## HISTORIC AND DESIGN REVIEW COMMISSION

### Agenda Item No: 21

**HDRC CASE NO:** 2016-203  
**ADDRESS:** 431 ADAMS ST  
**LEGAL DESCRIPTION:** NCB 2880 BLK 5 LOT 9  
**ZONING:** RM4 H  
**CITY COUNCIL DIST.:** 1  
**DISTRICT:** King William Historic District  
**APPLICANT:** Jorge Araujo  
**OWNER:** Scott & Hoda Cummings, Scott & Hoda Cummings  
**TYPE OF WORK:** Demolition of accessory structure and new construction  
**REQUEST:**

HARDIE BOARD & BATTEN SIDING

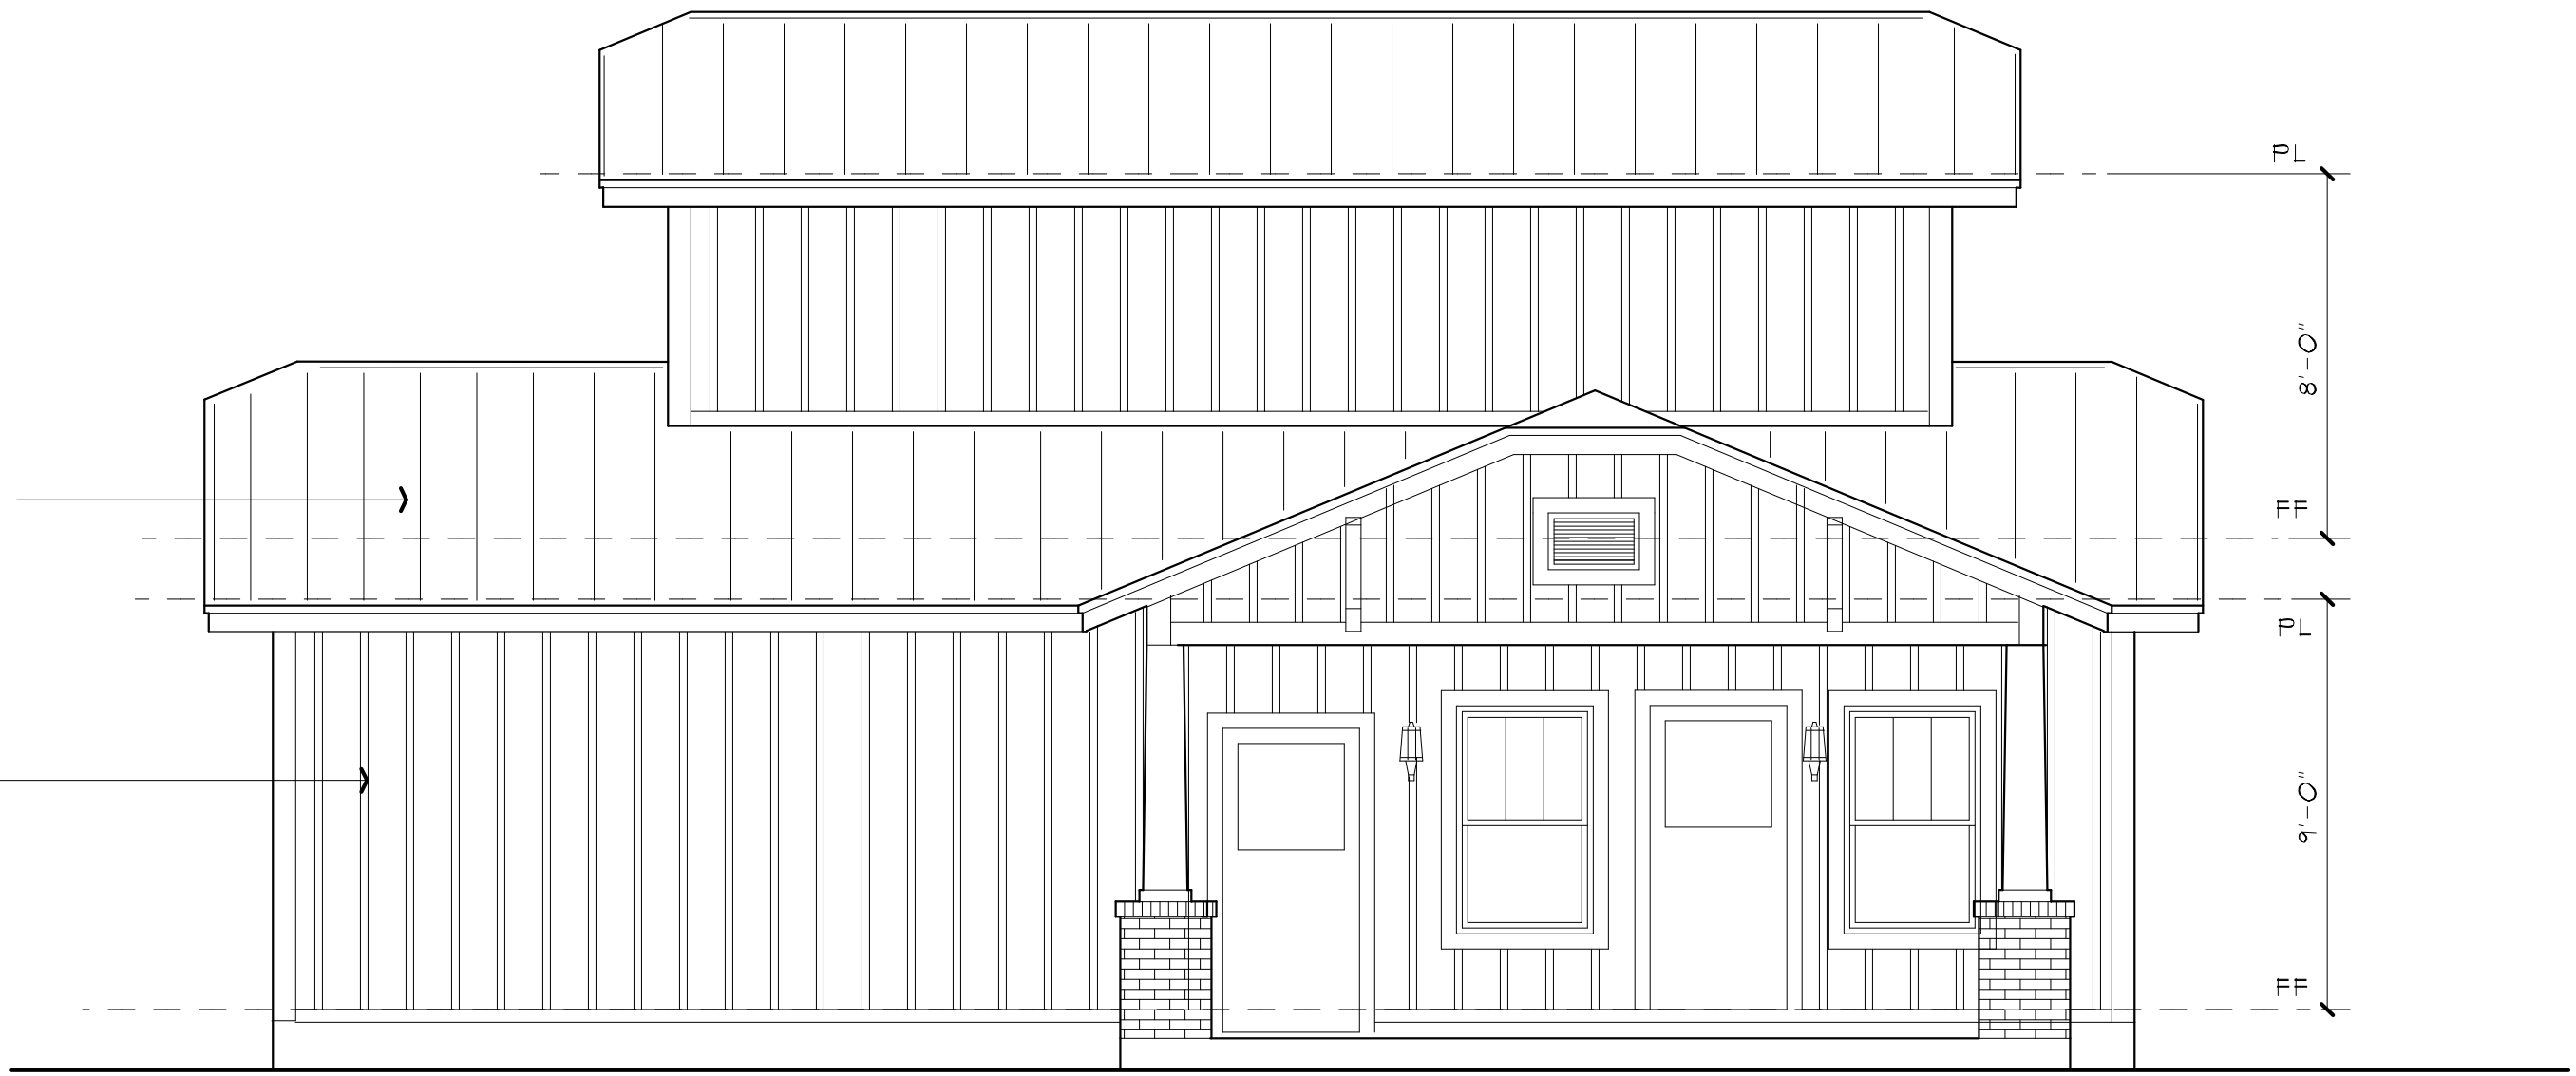
- c. **MASSING & FORM** – According to the Guidelines for New Construction 5.A.i, new accessory structures should be designed to be visually subordinate to the primary historic structure in terms of their height, massing and form. The primary historic structure at 431 Adams features a single story with a foundation height of approximately two feet and an overall height of 21' – 0". The applicant has proposed to construct an accessory structure to include two levels and an overall height of 23' – 1 ½". In terms of height, while the proposed structure is slightly taller than the primary historic structure, staff finds its height is generally appropriate in context with other accessory structures along both Adams and Barbe.

- f. **CHARACTER** – At this time, the applicant has proposed façade materials to include Hardi Board siding and brick consistent with the brick of the primary historic structure. The applicant however has proposed for vertically oriented siding for the accessory structure and has included craftsman style architectural elements on a structure that features a vertically oriented siding. This is architecturally inappropriate.

- g. **WINDOWS & DOORS** – The applicant has noted that the accessory structure is to feature aluminum windows that are to match the profile of the windows found in the primary historic structure. Staff finds that wood windows would be more appropriate. Each window should be inset within walls at least (2) inches. In regards to window placement, the applicant has proposed for the accessory structure to include walls that at times are void of fenestration of façade separation. This is neither appropriate nor consistent with the Guidelines. Staff recommends the applicant propose fenestration patterns that provide façade separation and negate long expanses of blank walls.

- h. **GARAGE DOORS** – In regards to the proposed garage doors, the applicant has not noted a specific material, however, staff finds that the applicant should study existing garage door found throughout the district that are architecturally contributing.

1. That the applicant reduce the proposed massing and footprint of the proposed accessory structure to be more appropriate for the primary historic structure.
2. That the address the architectural inconsistencies including siding orientation and the proposed garage doors.
3. That the applicant provide information in regards to the proposed windows including their installation.

4. That the applicant introduce additional windows or make other design changes to reduce the overall lack of fenestration.
